## REQUEST FOR COUNCIL ACTION

AGENDA SECTION:	ORIGINATING DEPT:	ITEM NO.
PUBLIC HEARINGS	PLANNING	F-16
ITEM DESCRIPTION: Preliminary Plat # 03-04 to be known as Manor Woods West Fourteenth, by Forbrook - Bigelow Development, LLC. The plat contains 32.68 acres to be subdivided into 69 single- family home lots and 3 outlots. The plat includes a request for a <u>Substantial Land Alteration Permit</u> to allow grade changes in excess of 10 feet in 5 different areas. The property is located south of 5 <sup>th</sup> Street NW, north of Manor Brook Drive NW, west of Manor Park Drive NW and allows of the continuation of Manor Ridge Drive NW.		PREPARED BY: Mitzi A. Baker, Senior Planner

Preliminary Plat # 03-04 to be known as Manor Woods West Fourteenth, by Forbrook - Bigelow Development, LLC. The plat contains 32.68 acres to be subdivided into 69 single- family home lots and 3 outlots. The plat includes a request for a Substantial Land Alteration Permit to allow grade changes in excess of 10 feet in 5 different areas. The property is located south of 5<sup>th</sup> Street NW, north of Manor Brook Drive NW, west of Manor Park Drive NW and

Proposed GDP Amendment 1103

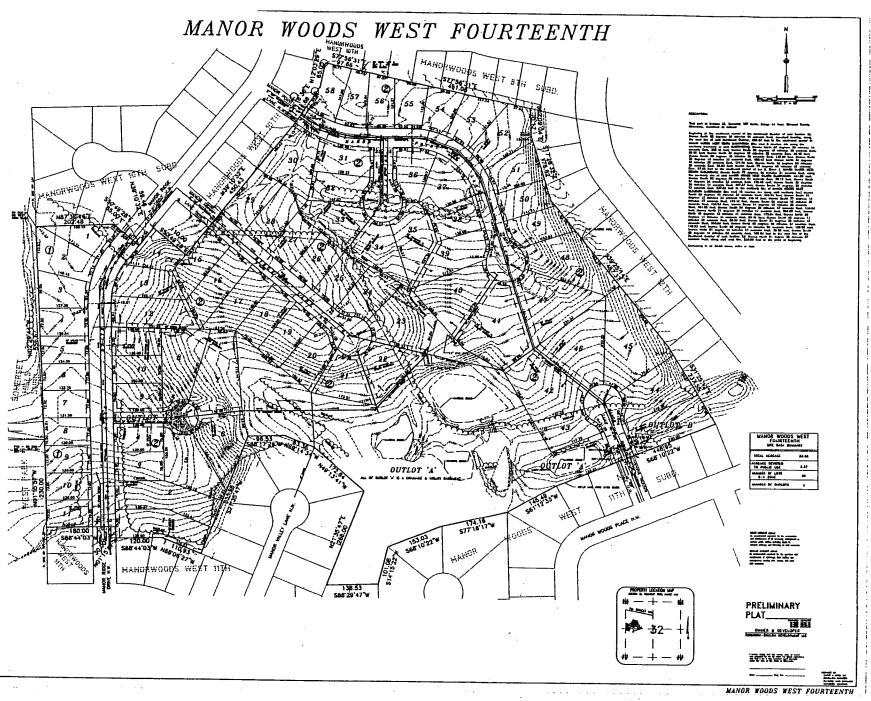
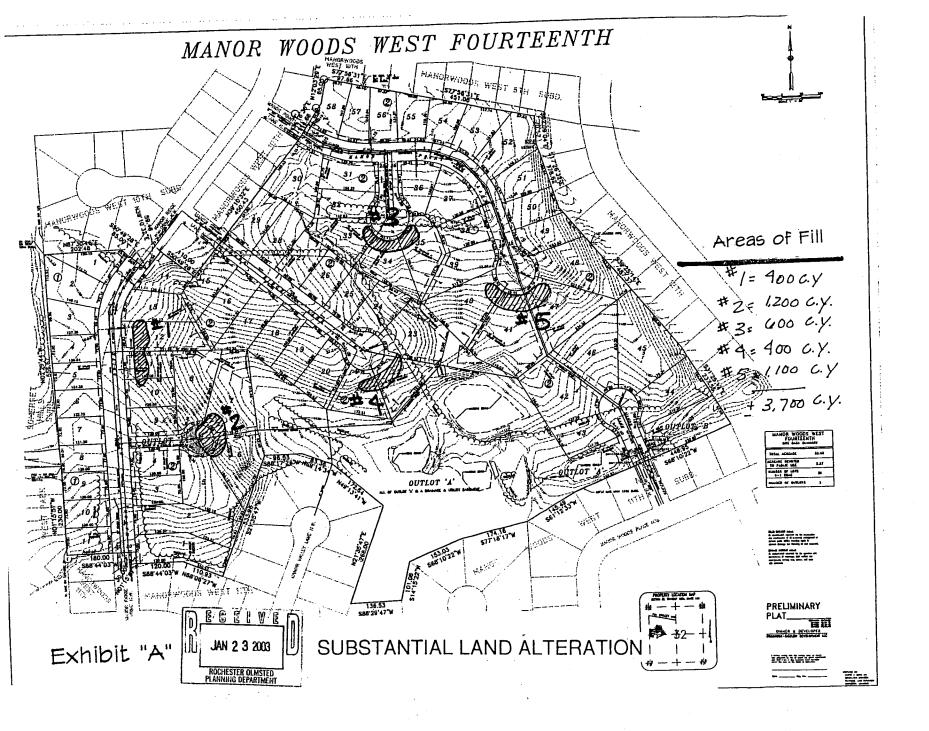
This property is included in the Manor Woods West General Development Plan. A Type I (staff review) amendment to the GDP is being considered concurrent with this preliminary plat, to add the private road cul-de-sac on the west side and the public cul-de-sac from the south sides of the development.
